HV PERMIT P27809 - 115 VICTORIA PARADE, FITZROY FORMER COMMONWEALTH NOTE AND STAMP PRINTING DEPARTMENT AMENDMENT APPLICATION

1. INTRODUCTION

Figure 1: Extent of proposed window replacement (plan prepared by Lyons)

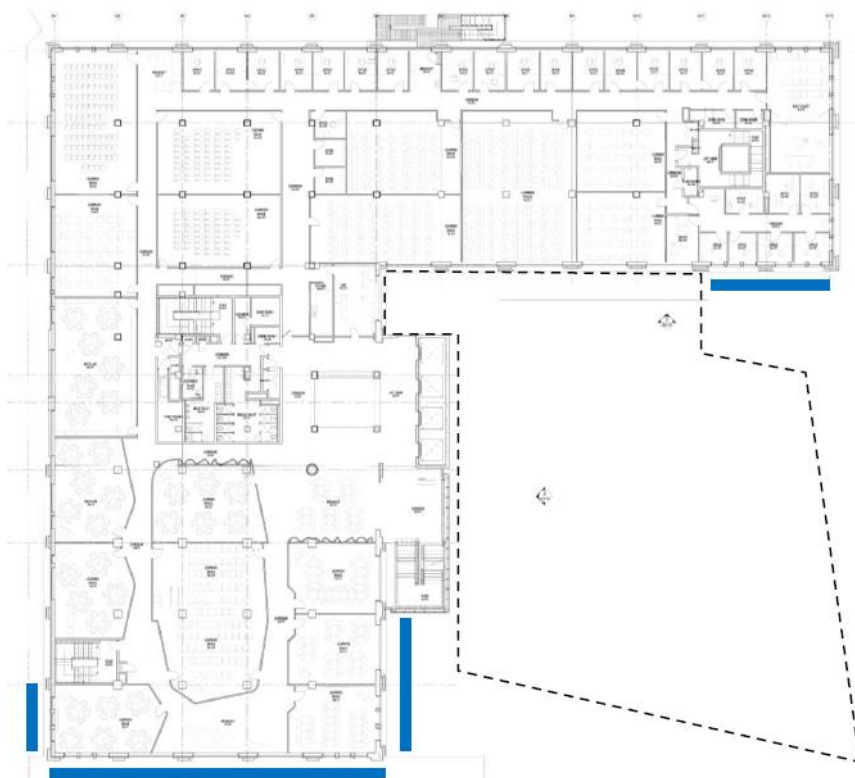
As a way forward we seek to amend this permit condition to contain the window reinstatement to two bays of windows on the east elevation, all windows on the south elevation, one bay of windows on the west elevation, and all visible windows on the south elevation of the Napier Street wing (illustrated overleaf).

This approach focuses on those elements of higher visibility, and balance to the building overall, while assisting in delivery of the project. The extent of replacement is in line feedback provided in response to the diagram discussed in our meeting (ie, including the windows in the Napier Street return sought by Heritage Victoria officers).
